**WHITE LAKE TOWNSHIP  
ZONING BOARD OF APPEALS  
REGULAR VIRTURAL MEETING  
May 27, 2021 at 7:00 PM**

**TO:** Zoning Board of Appeals  
**FROM:** Justin Quagliata, Staff Planner  
**DATE:** June 24, 2021

DESIGNERS:  
ANTHONY MARRUCCO  
(586) 850-8080

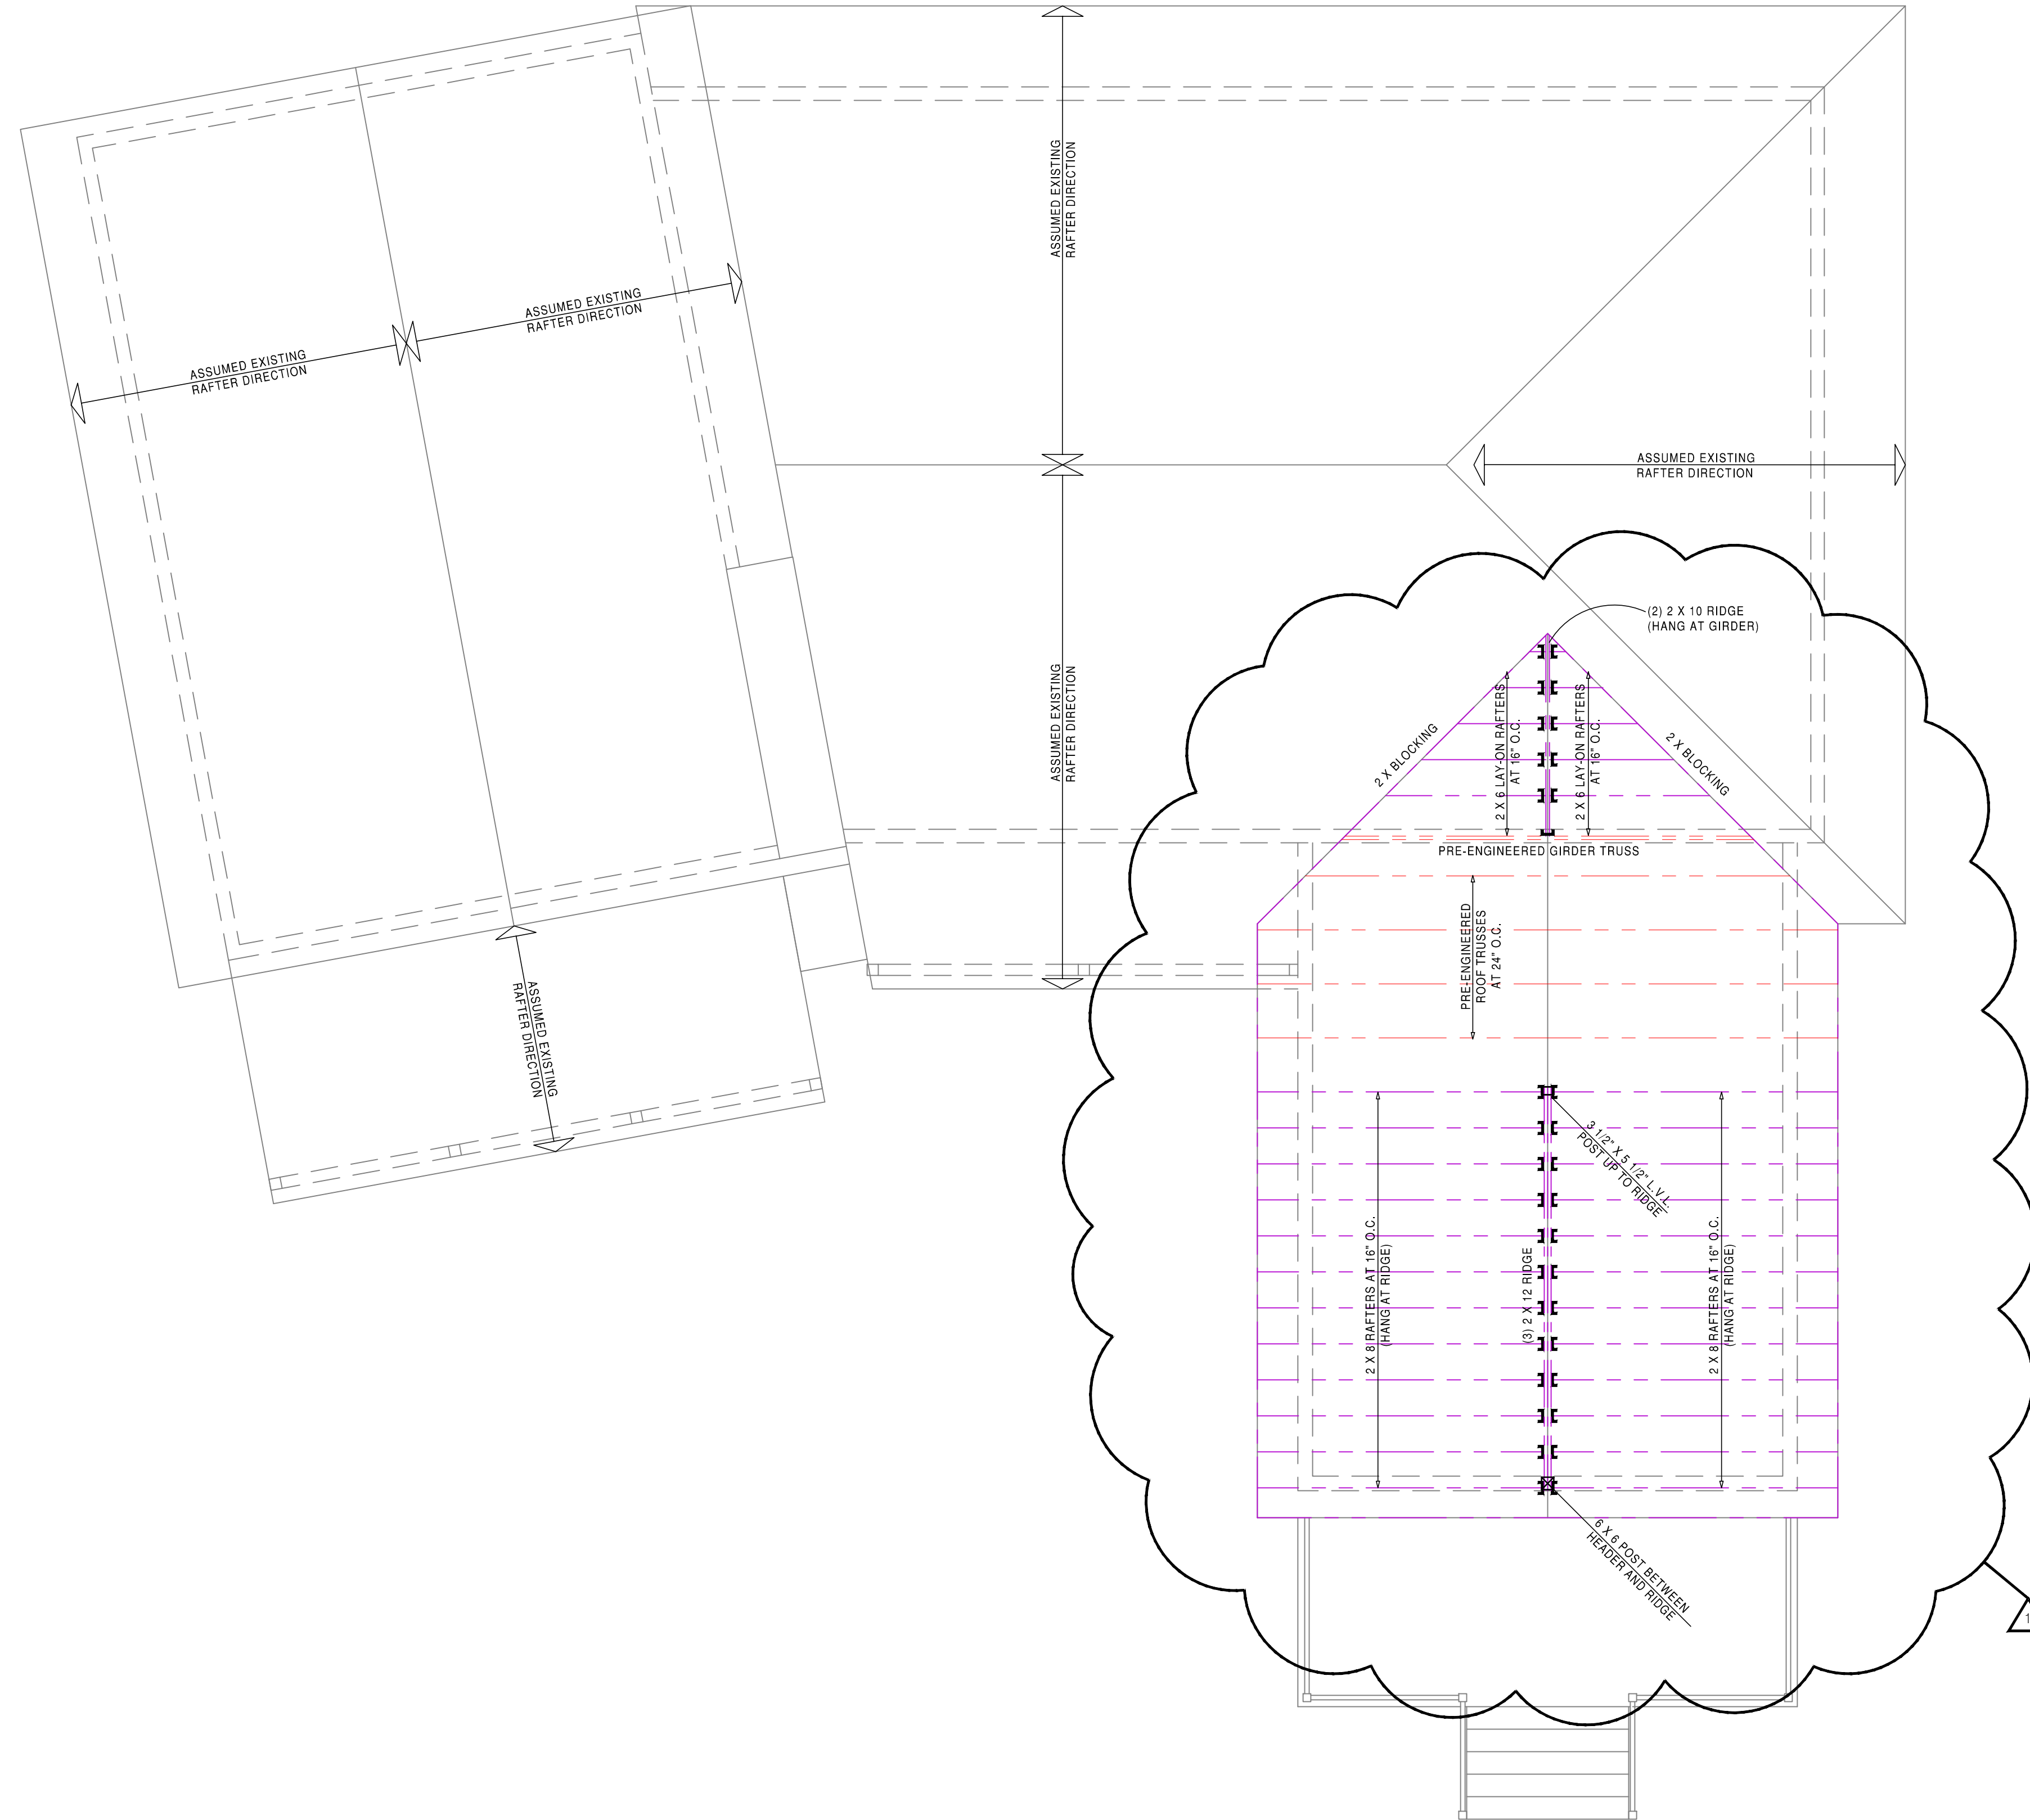
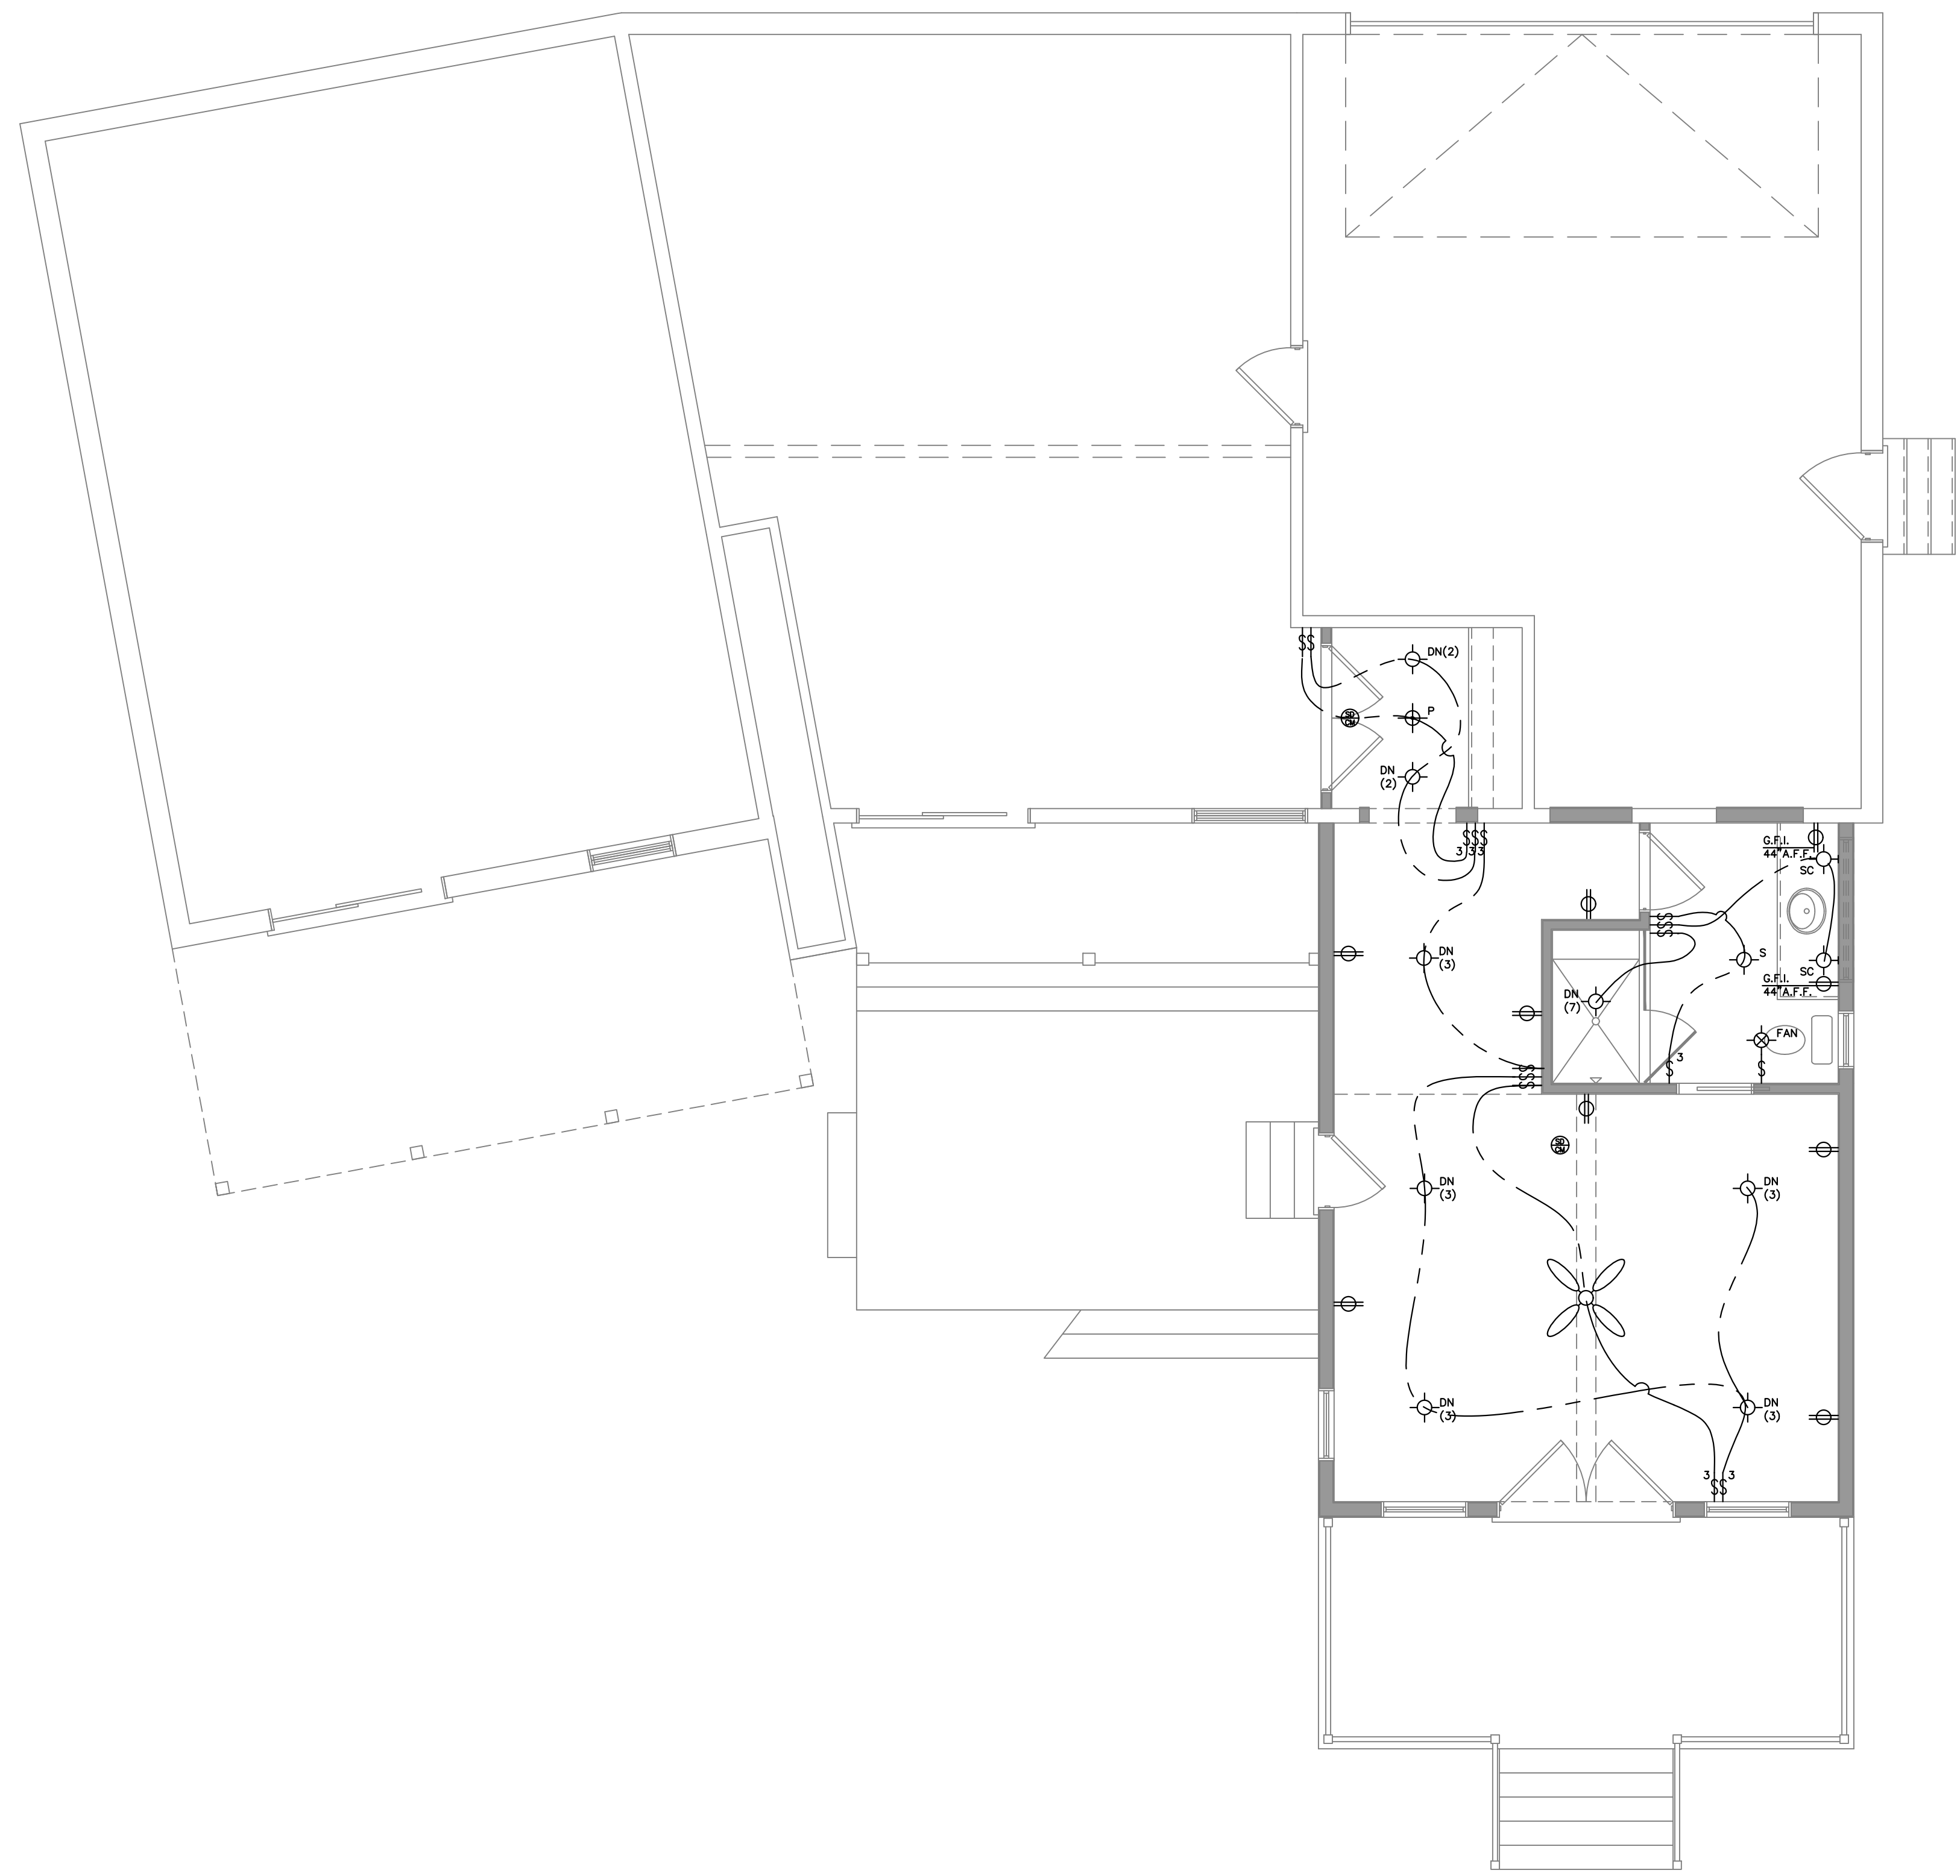
The proposed addition is 444 square feet in size and located six 6.6 feet from the east side lot line. The proposed deck is 148 square feet in size. The architectural plans note added area would be 535 square feet. The addition and deck total 592 square feet in size. Additionally, the architectural plans show the roof overhang of the addition located 5.25 feet from the east side property line. With the proposed side setback and 1.5-foot overhang for the addition, the roof would be 5.1 feet from the east side property line. If the Board approves the request, the plans need to be revised for consistency.

- The Applicant shall obtain all necessary permits from the White Lake Township Building Department.
- An as-built survey shall be required to verify the roof overhang setback from the east side lot line.
- The plans shall be revised for consistency to clarify the roof overhang setback.
